## ***Technical Service Bulletin***

**Subject:** TSB - CP100 HW RELEASE LCD W/ BACKLIGHT

**Product(s)  
Referenced:** CP100 Electrocardiograph

**Summary:** Change to a new backlit version of the CP100 LCD display. Replace old CP100 LCD 701588 with new 711715.

**Required Materials:**

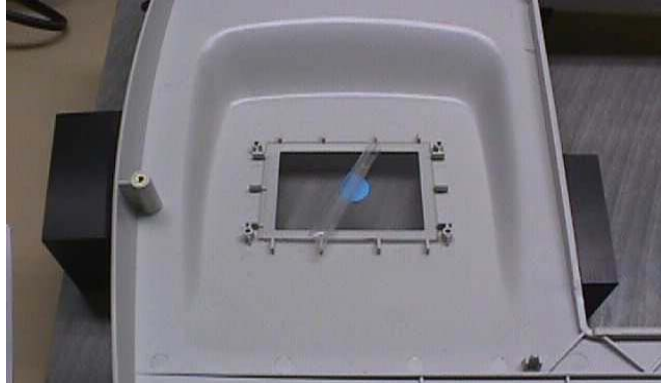
LCD change requires a change to the LCD mounting screws length. Replace old screw 106124-4 with new 106124-34 (4 screws).

Change to a new version of the CP100 keyboard for the backlight on the new LCD to function. Replace old keyboard 403311 with new 405641.

1. 711715 - LCD, B&W, 320 x 240, POWERTIP 3.9" W/BL  
(Was 701588 - LCD POWERTIP 3.9, NORMANDY)
2. 106124-34 - SCREW 4-20 .375 PAN PHILLIPS  
(Was 106124-4 - SCREW 4-20.250 PAN PHILLIPS)
3. 405641 - PURCHASED ASSY KEYBOARD CP100  
(Was 403311 - ASY, QWERTY KEY BOARD, CP100, NORMANDY)
4. 701521 - GLARE SCREEN, LIMITED, NORMANDY
5. T18772 - GH\_FDT SURFACE QUALITY COMPARISON GUIDE

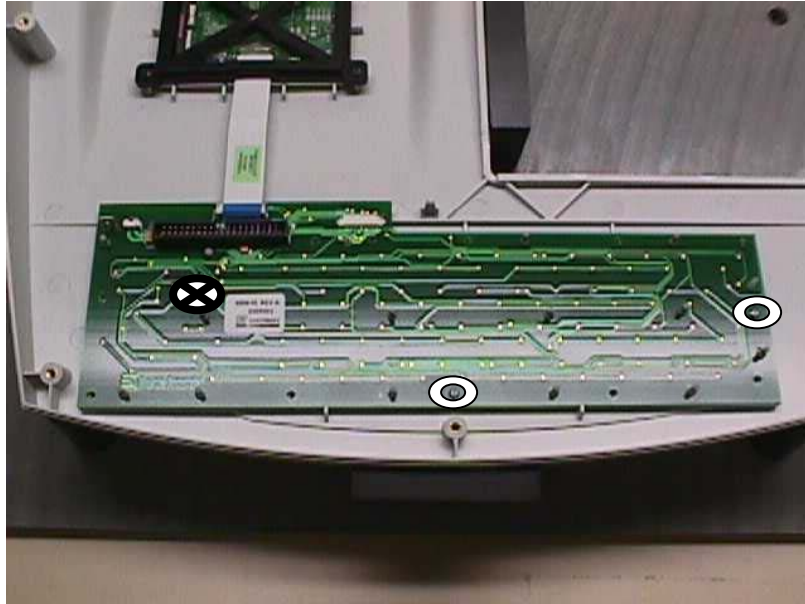
4. NOTE: DO NOT use anything but air to clean the smooth shiny side of glare screens. Clean Optical cloth can be used on the rough side of screen.
5. Insert the Screen into the Top Cover as shown and remove the protective coating (with the colored dot). The side of the Screen with the colored dot needs to face the LCD screen.

6. Remove the protective covering from the LCD (711715) and install into cover. Blow off the LCD screen and the Glare screen prior to installation to remove any dust carefully. Place bracket (701035) over the LCD as shown and secure with four Screws (106124-34).

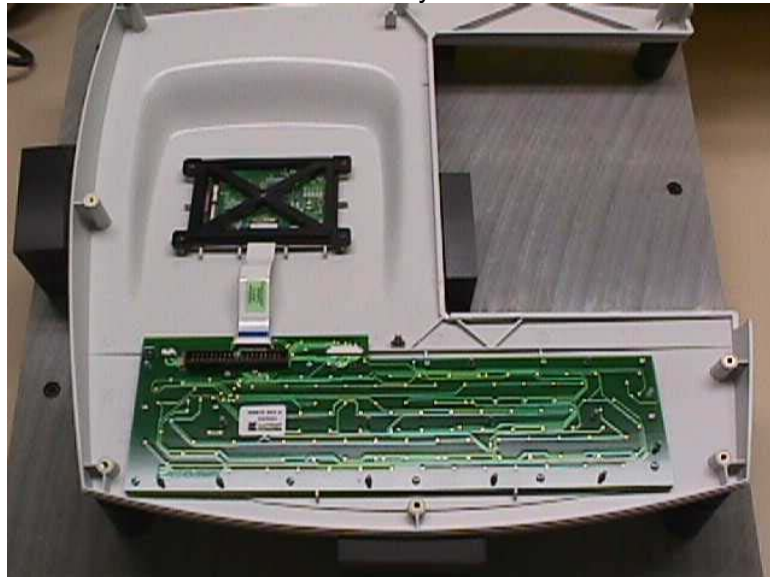
7. Install Keyboard (405641) with 2 Screws (703680) circled below. These two screws locate the keyboard properly and must be installed first.

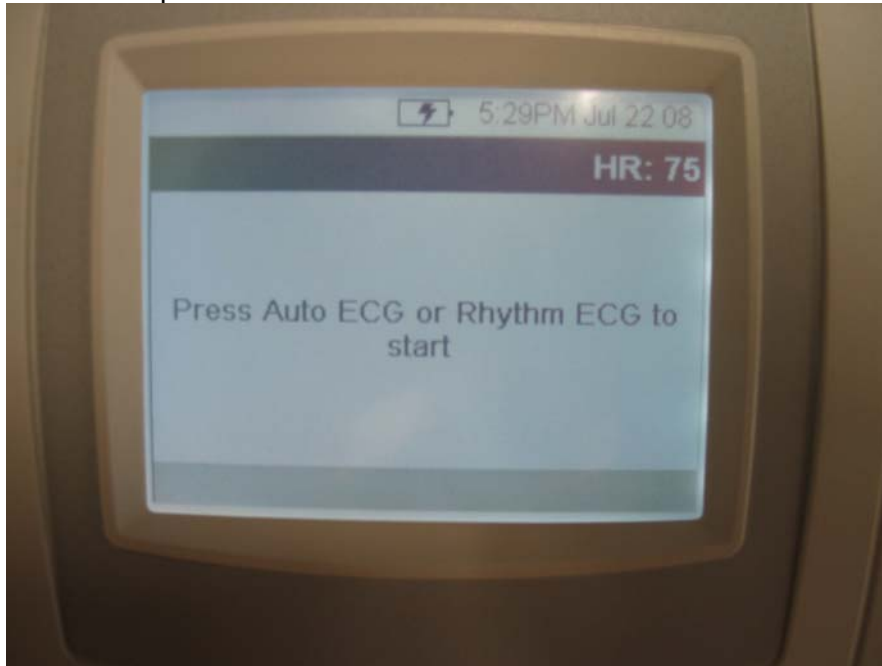
8. Install the remaining 11 Screws (703680) into the Keyboard. The screw designated with the "X" above is to be installed last.
9. Install Flex Harness from LCD to Keyboard as shown.

10. Examine the assembly and insure that the glare screen fits tightly against the housing around the entire perimeter of the screen.
